INDIANA DEPARTMENT OF TRANSPORTATION

APPROVED MINUTES

June 17, 2010 Standards Committee Meeting
(Changes to the Final Draft Minutes by Action of the Committee
on September 16, 2010 shown as Highlighted Yellow)

RE: Minutes for the June 17, 2010 Standards Committee Meeting

ADDED FIGURE 77-4H TYPICAL WIRELESS VEHICLE DETECTION SYSTEM DESIGN (DRAFT)

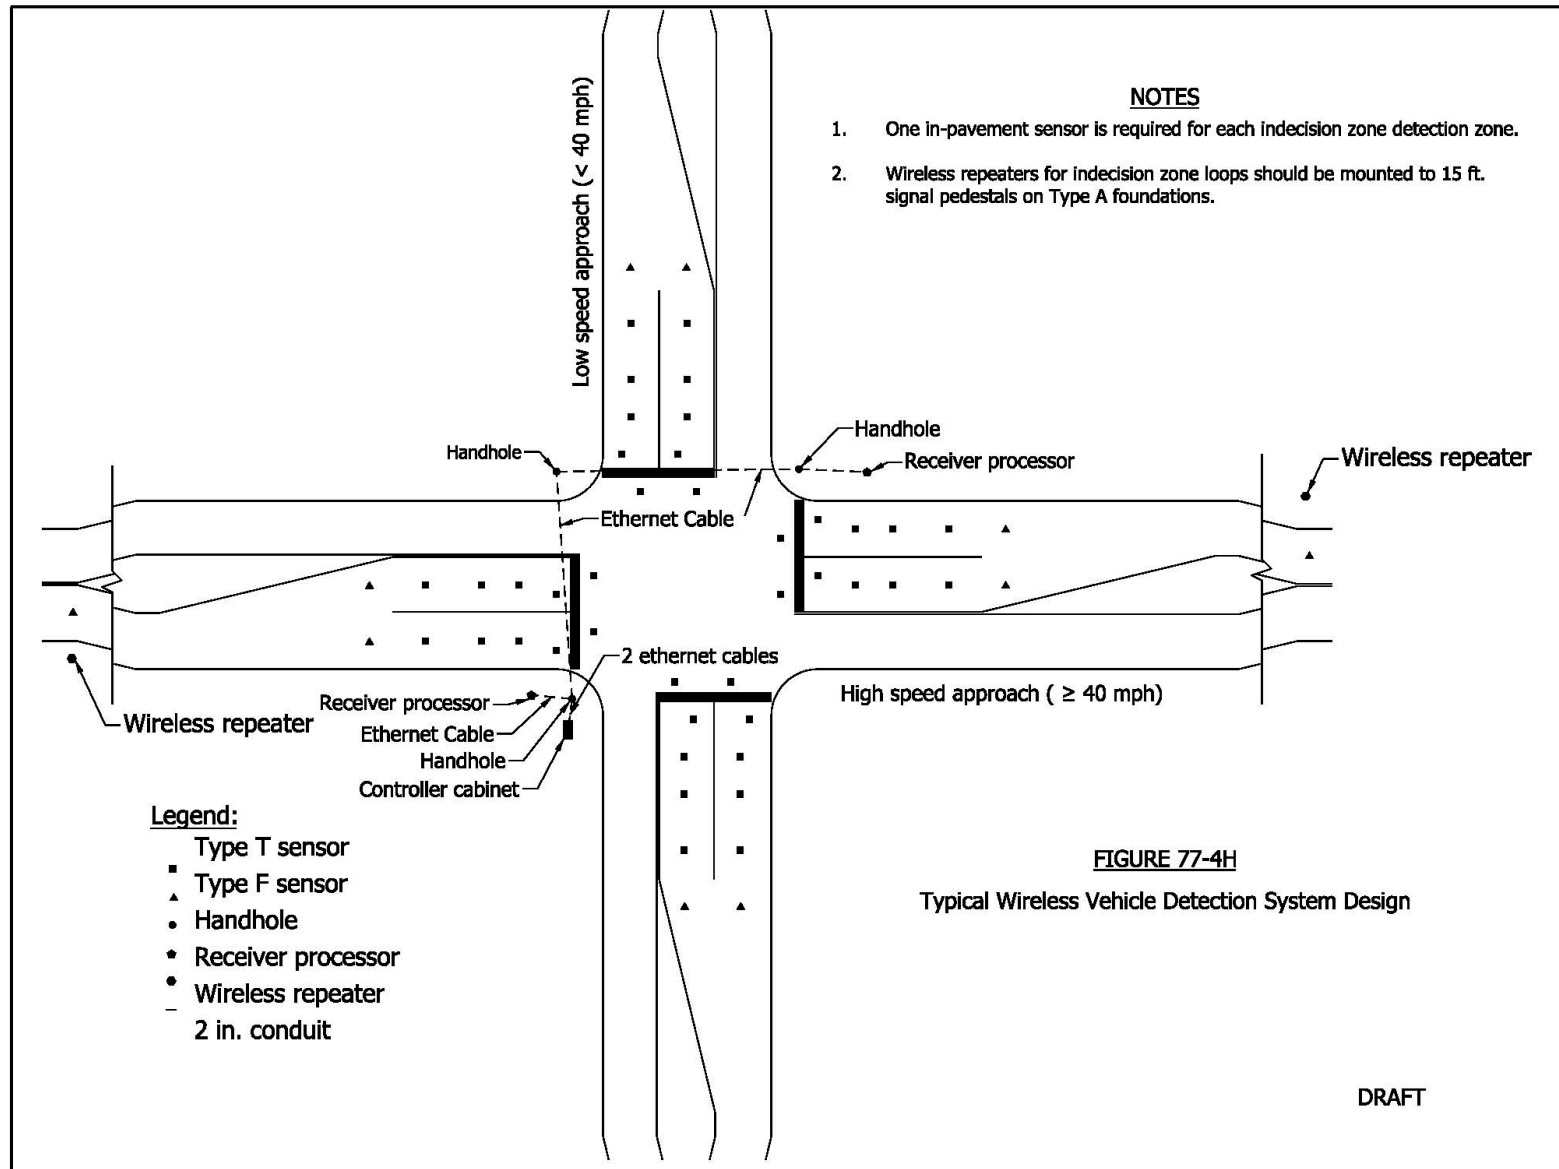
Detection systems other than inductive loops require plan detailing. See Figures 77-4H and 77-4I for typical plan details. In order to use a type of detection other than inductive loops, INDOT designers and consultants and local agency consultants must provide and submit documentation that 2 of the following 3 conditions have been met:

PROPOSED NEW STANDARD DRAWING 805-SGDW-01 WIRELESS VEHICLE DETECTORS STOP BAR DETECTION ZONE (DRAFT)

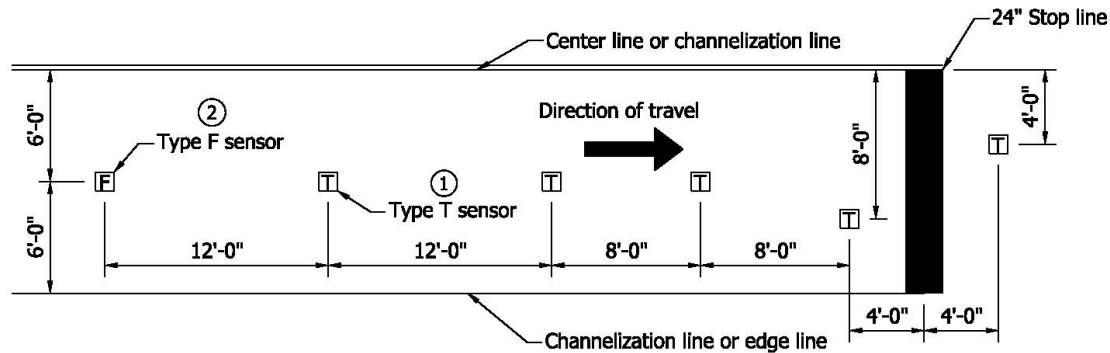
Mr. Keefer asked about the life of the batteries especially in the detectors and the answer was that the detector batteries lasted about 10 years in the detectors and 2 years in the repeaters. Mr. Keefer then asked if other states were using this technology. The answer was that there are other states as well as our use of it on SR37 in Noblesville.

Mr. Andrews asked if there was proof that the batteries lasted for the stated timeframes and if there was any way to track how long the batteries had been in place. Mr. Richards stated that the company had not been around for 10 years yet so the detector battery life was an estimate at this time and there is a program to track the various intersections throughout the state and this could probably be added to that program.

Mr. Miller asked if intersection would revert to a timer if there was a detector failure and the answer was yes.

Mr. Andrews asked what the cost to replace the batteries was and who would be responsible for the replacement cost and labor. Mr. Richards stated that the repeater batteries were approximately \$80 each and the detectors had to be completely replaced at a cost of \$400-\$500 each. The cost would come out of the traffic management budget and the work would be performed by maintenance crews.

- ① Type T Sensors detect only vehicle presence.
- ② Type F Sensors detect vehicle presence and provide vehicle counts.
3. There should be at least $\frac{1}{4}$ " and no more than $\frac{1}{2}$ " of clearance between the top of the sensor and the top of the pavement
